Title of Change:	packing quantity increase from 450ea to 1350ea for TO247&TT3PN and tube pin dimension and color change
Effective date:	15 Feb 2022
Contact information:	Contact your local onsemi Sales Office or Daisy.Zhi@onsemi.com
Type of notification:	This Product Bulletin is for notification purposes only. onsemi will proceed with implementation of this change upon publication of this Product Bulletin.
Change Category:	Test Change
Change Sub-Category(s):	Shipping/Packaging/Marking

Currently:

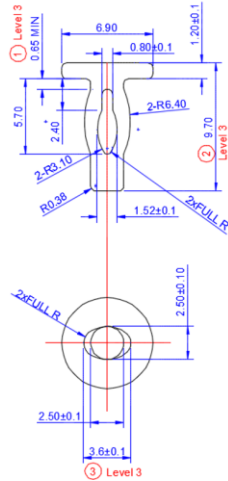
Tube Pin Dimension & Color Change

Note:
 1. MATERIAL: NYLON
 2. COLOR: GREEN/RED
 3. STANDARD TOLERANCE = +/-0.20
